TITLE: PNEUMATIC - DISTRIBUTION - INSTALL NEW BLEED DUCT WELDED ASSEMBLY COMPRISING NEW GIMBAL STANDARD REFERENCE - LHS

MODIFICATION No.:
115137L91114

Figure ICN-A350-A-36XXP021-A-FAPE3-05CF4-A-001-01 SHEET 1/2

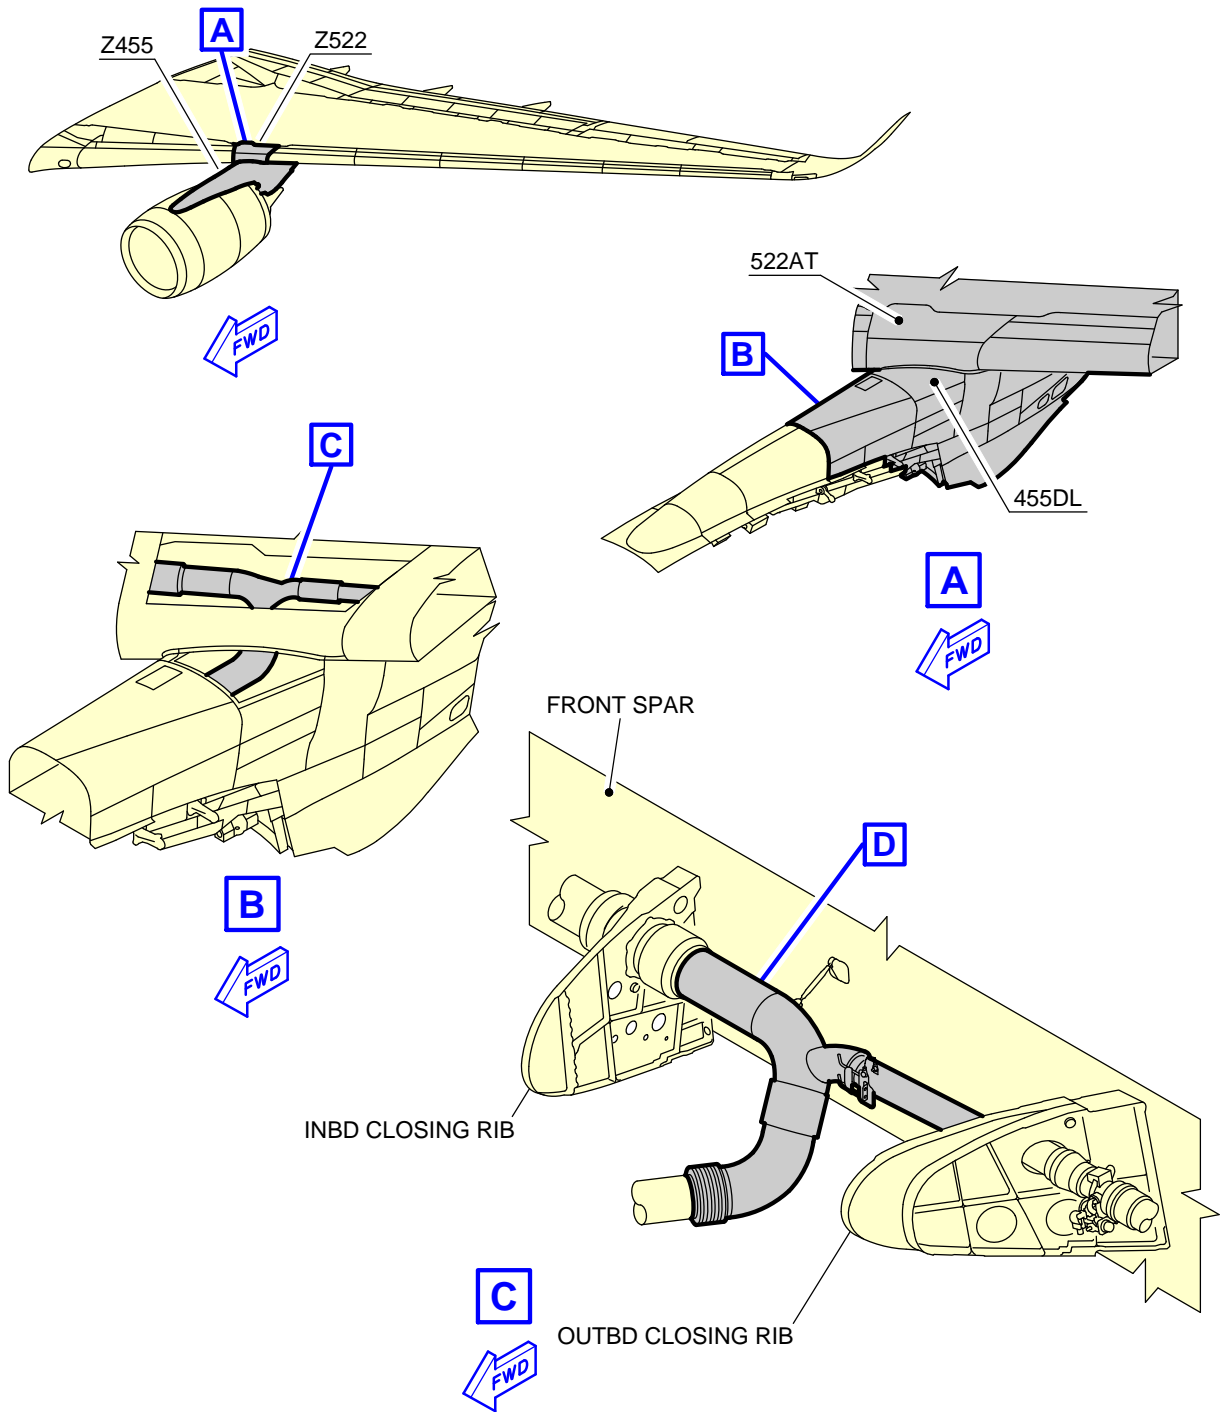
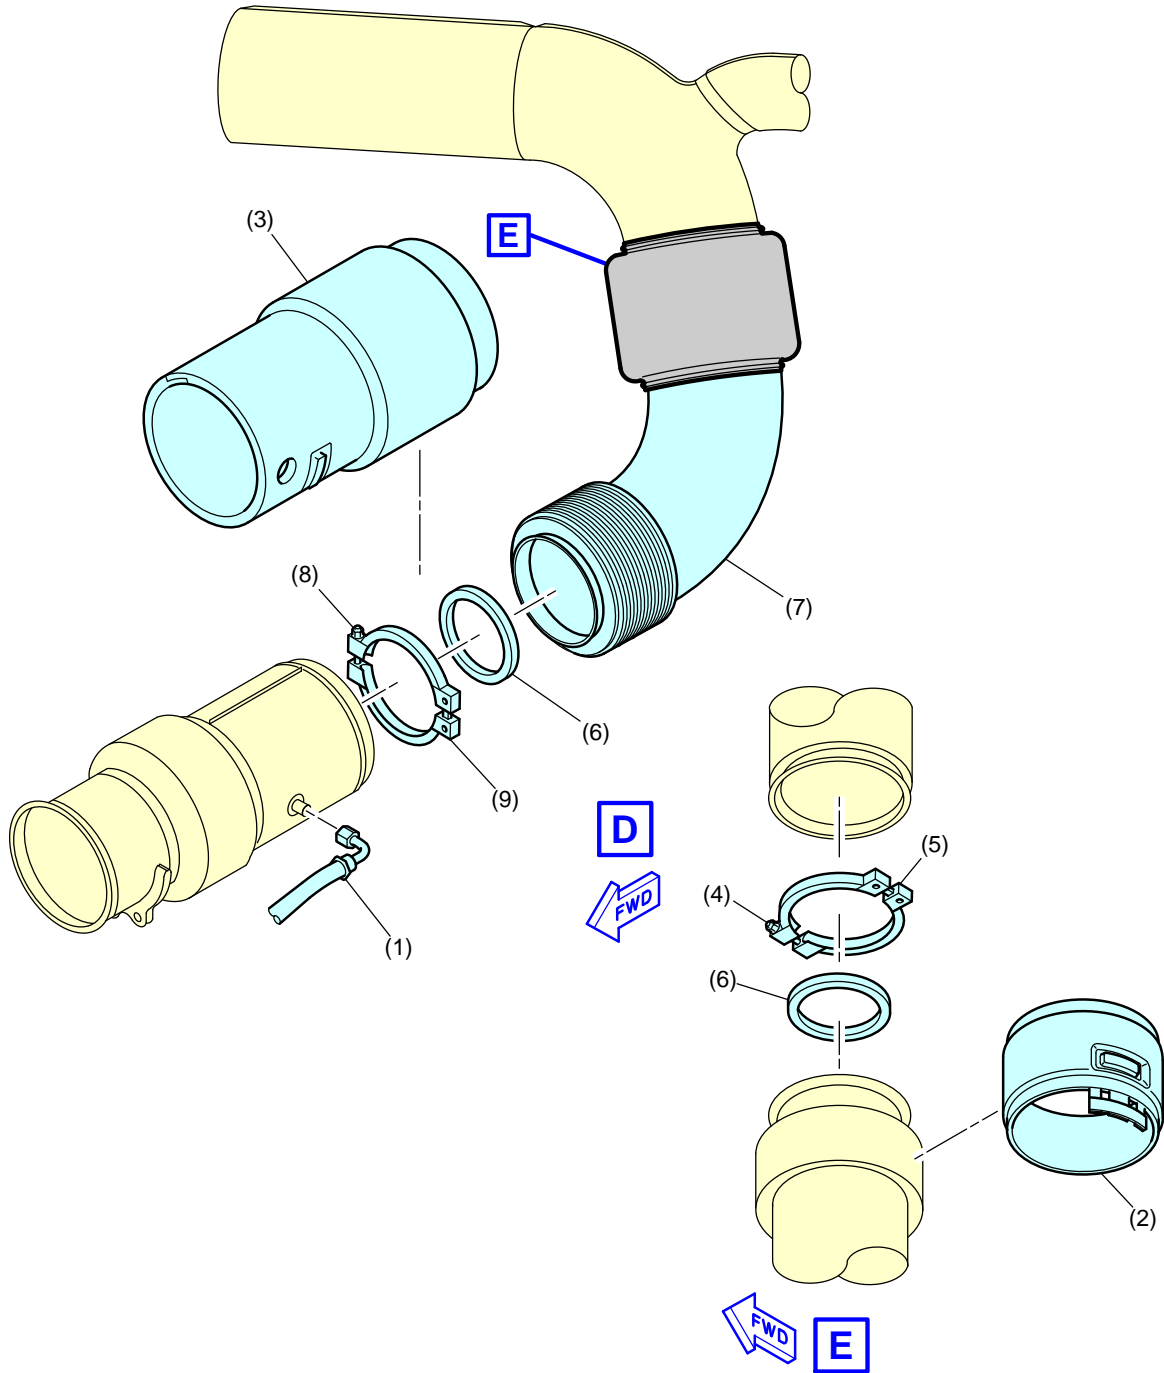
Refer to Ref. Fig. Removal of the Bleed Air Duct from the LH Wing to Pylon Interface

- 1 Disconnect the hose assembly, Item (1), to remove the muff, Item (3).
- 2 Release the velcro tapes of the muffs, Item (2) and Item (3), to open these.
- 3 Remove the muffs, Item (2) and Item (3):

- 6 Remove the duct, Item (7):
- | | | | | |

| 1 | DUCT ASSY | V3616500000400 | Item (7) | Discard |

- 7 Remove the applicable E-seal, Item (6):
- | | | | | |

| 2 | E-SEAL | | Item (6) | Discard |

Figure ICN-A350-A-36XXP021-A-FAPE3-05BQ8-A-001-01 SHEET 1/3

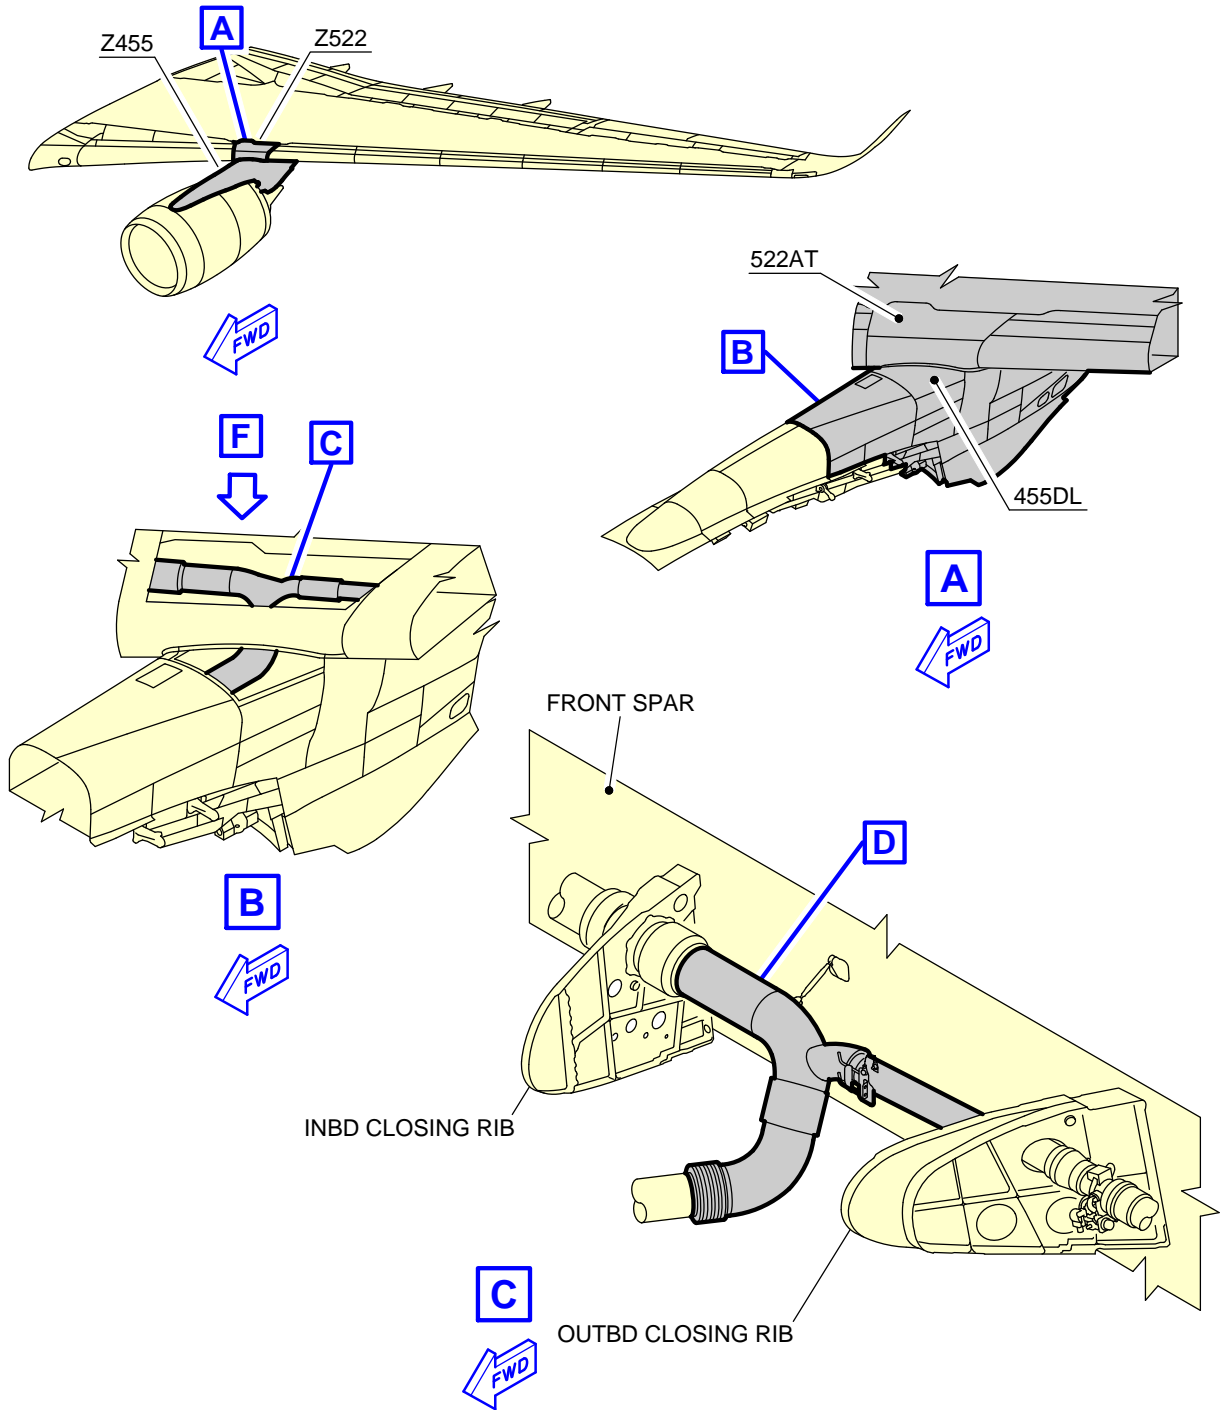
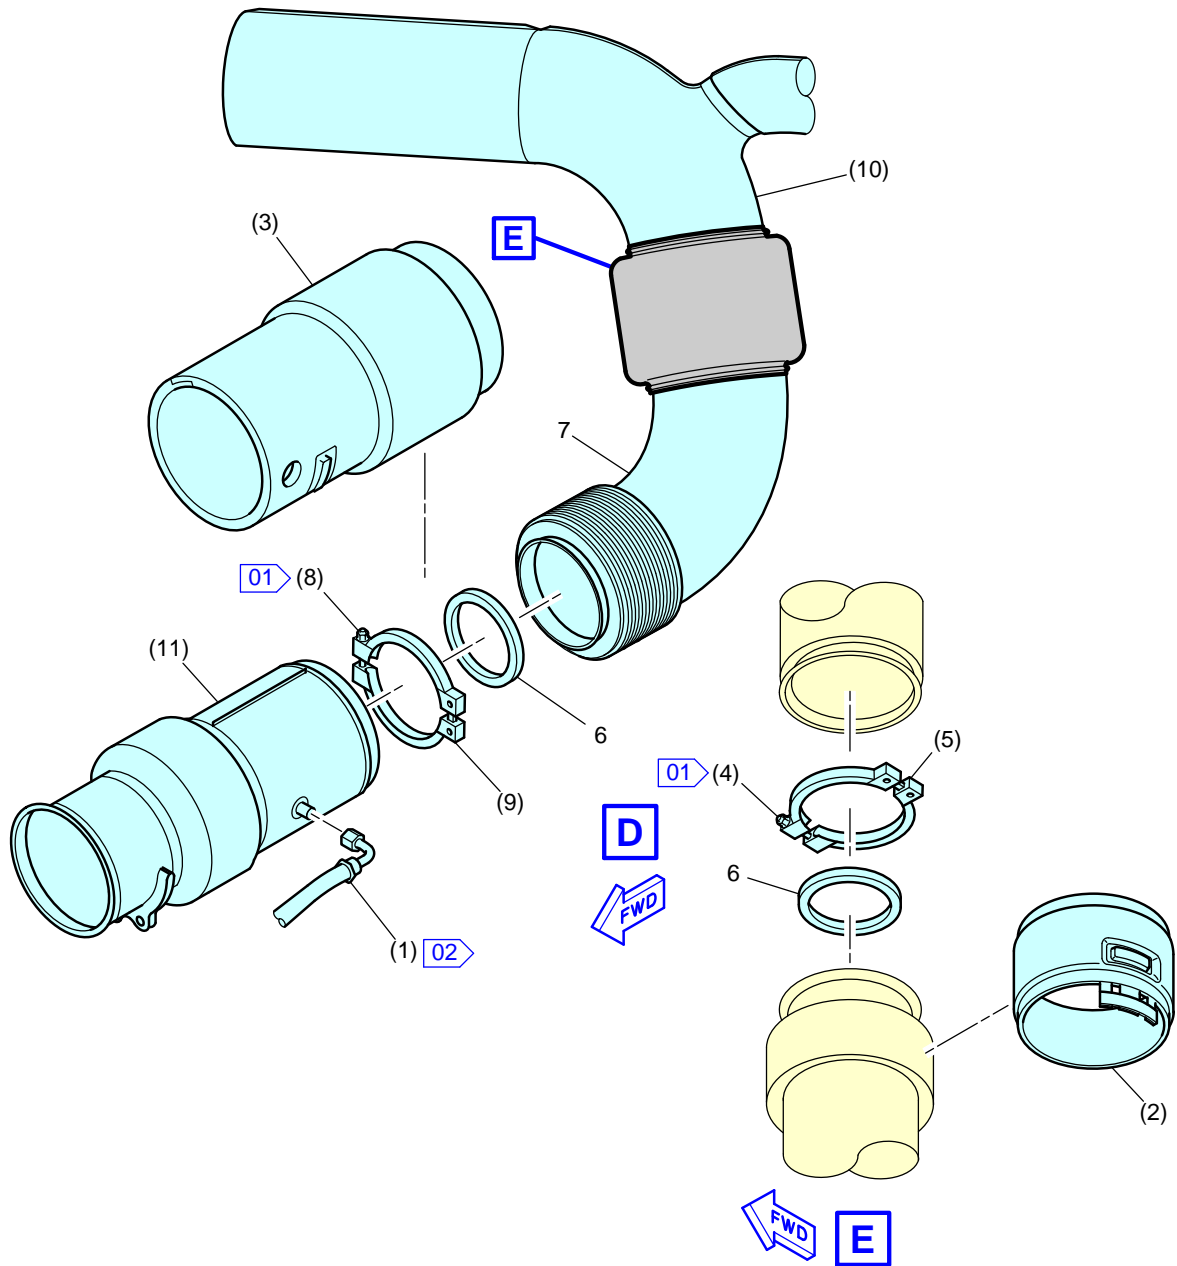
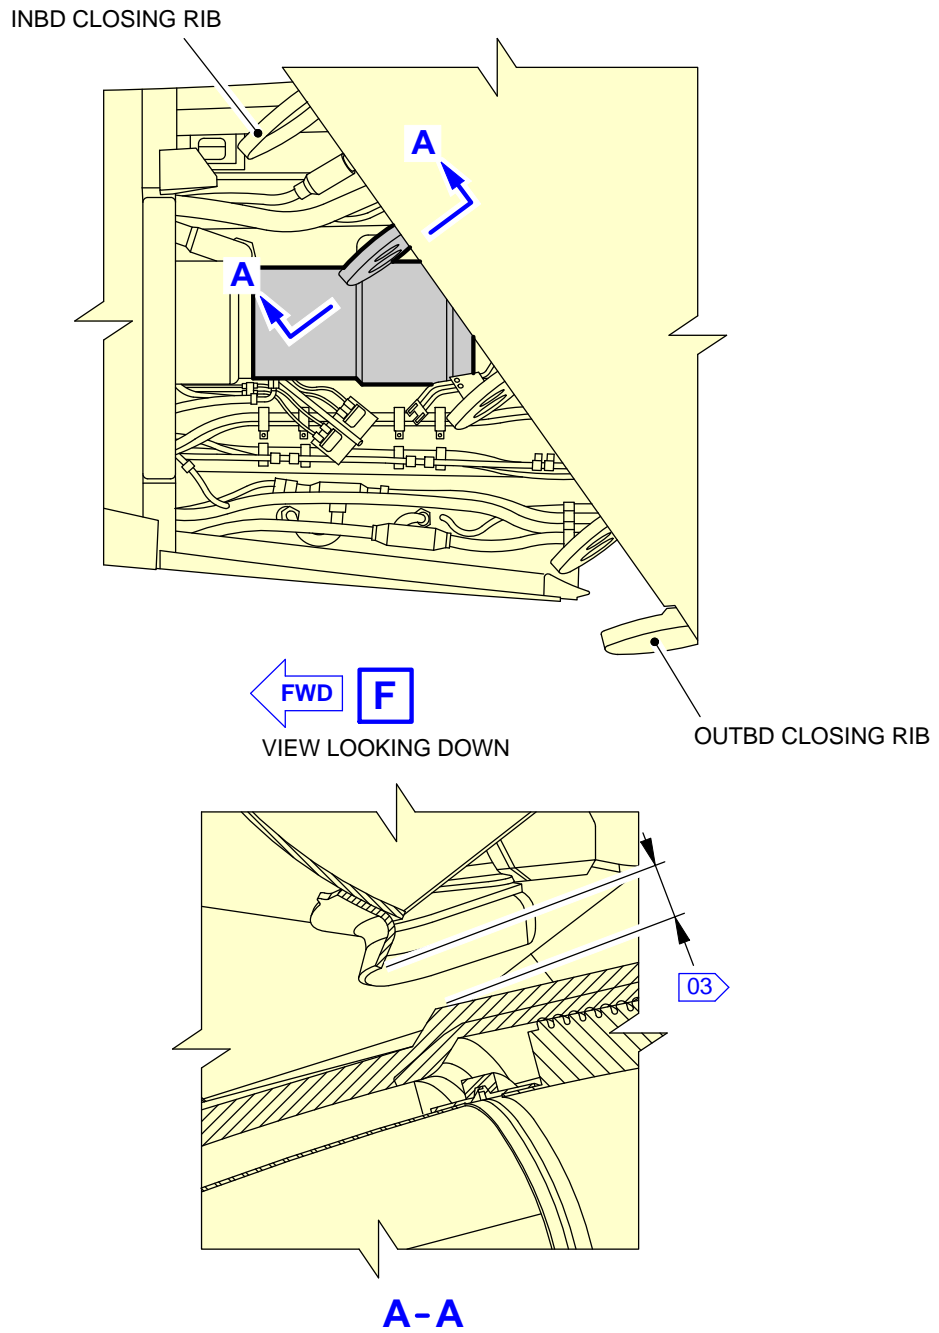
- (b) Install the new duct assy:
Refer to Ref. Fig. Installation of the Bleed Air Duct from the LH Wing to Pylon Interface
- 1 Remove the blanking plug from each disconnected duct end.

- 2 Put the duct, Item 7, in position between the pipe junction, Item (10), and the pipe junction, Item (11):
- | | | | |

- 4 Engage the duct, Item 7, with the pipe junction, Item (10), and put the clamp, Item (5), on the E-seal, Item 6:
- | | | | |

8 Torque the self locking nuts, Item (4) and Item (8), to between 3.39 and 3.95 Nm (30.004 and 34.960 lbf.in.).

NOTE: Be careful to make sure to respect the minimum distance from the elements of structure at 20 mm (0.787 in.).

- 01** TORQUE THE SELF LOCKING NUTS, ITEM (4) AND ITEM (8), TO BETWEEN 3.39 AND 3.95 Nm (30.004 AND 34.960 lbf.in).
- 02** TORQUE THE HOSE ASSEMBLY CONNECTION, ITEM (1), TO BETWEEN 24.30 AND 31.60 Nm (215.073 AND 279.684 lbf.in).

03 MINIMUM DISTANCE FROM THE ELEMENTS: 20 mm (0.787 in).
